May 25, 2017

Washington State Department of Ecology  
PO Box 47775  
Olympia, Washington 98504-7775

Subject: Response to Ecology Comments on  
Shallow Soil and Groundwater Treatment Work Plan  
318 State Avenue NE  
Olympia, Washington  
File No. 0415-049-07

# Regenesis Remediation Services Injection Trailer

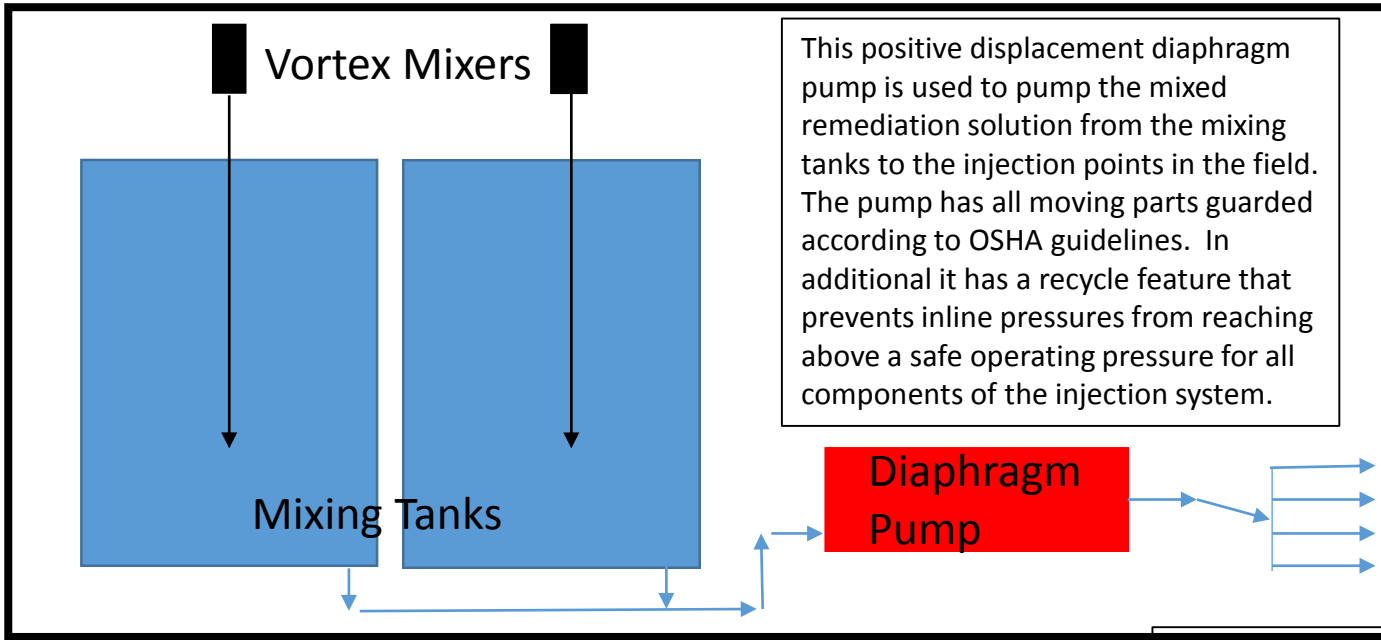
8. Though a contractor to complete the injections has not yet been selected, and thus the specific design of the field implemented chemical injection system may vary slightly, please provide a diagram of a standard design for the chemical injection system based on the equipment described in work plan Sections 5.1 (Equipment) and 5.3 (Treatment. Methods).

**Response:** Provided with the response to comments is a conceptual design of the chemical injection system based on the equipment described in the Work Plan.

## Downhole Injection Tooling

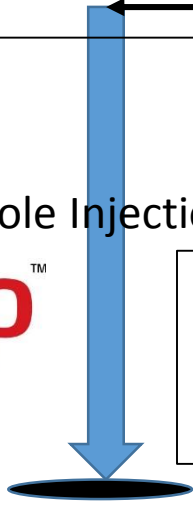
9. Specify what is meant in Section 5.4 (Treatment Monitoring) by "alternative injection tooling or techniques."

**Response:** A remediation contractor should have a few different types of injection tooling since one tool doesn't work in all situations. Standard types of injection tooling include retractable screen, expendable tip, open screen top-down tool, and pressure activated tool. The type of tooling has been added to the Work Plan.
